COVINGTON ESTATES JSP15-02

Consideration at the request of Biltmore Land, LLC for recommendation to City Council for approval of a Residential Unit Development (RUD) Plan – Alternate. The subject property is located in Section 31, north of Eight Mile and West of Garfield in the RA - Residential Acreage District. The applicant is proposing an RUD on a 48.83 acre parcel to construct 38 single-family residential units. The applicant is proposing a temporary relocation of the emergency access drive along the north property line from Garfield Road as an alternate to the current proposed emergency access drive location from the neighboring property to the east in the event easements are not acquired, as discussed at the March 9, 2016 public hearing.

Plan Review Center Report

RUD 2nd Revised Concept Plan - Alternate

ALTERNATE CONCEPT RUD PLAN

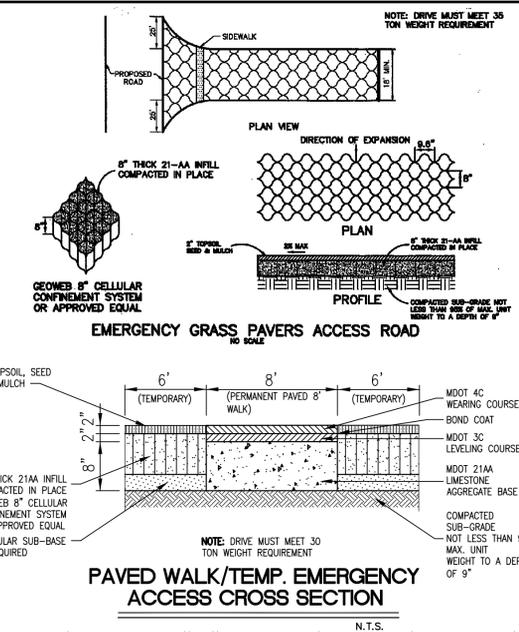
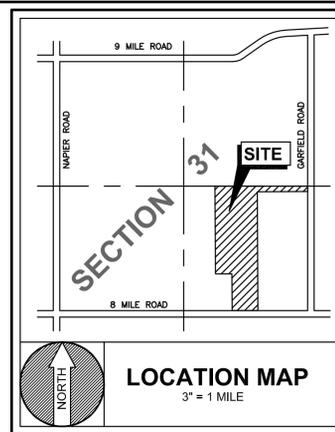
10. **Temporary Emergency Access: Provide the following notes on Sheet 3A: Alternate Concept RUD Plan stating:**
 - **"The temporary emergency access will terminate on completion of the development of the property to the east, when the emergency access between lots 12 and 13 in Covington Estates will become active and permanent."**

1. The applicant's letter needs to be revised to refer to the emergency access cross-section shown on the plans of grass pavers and asphalt, not gravel.
2. See Engineering review letter dated 02/29/2016 for additional comments.

1. The developer will begin coordination with Mr. Miller in the Engineering Division to begin the process of working with the City and DTE on the installation of the proposed entrance light.
2. The following notes will be provided on Sheet 3A: Alternate Concept RUD Plan:
 - a. "The temporary emergency access will terminate on completing of the development of the property to the east, when the emergency access between units 12 and 13 in Covington Estates will become active and permanent".
 - b. "The emergency access drive shall be mowed and kept clear of snow and ice as necessitated by the weather conditions".
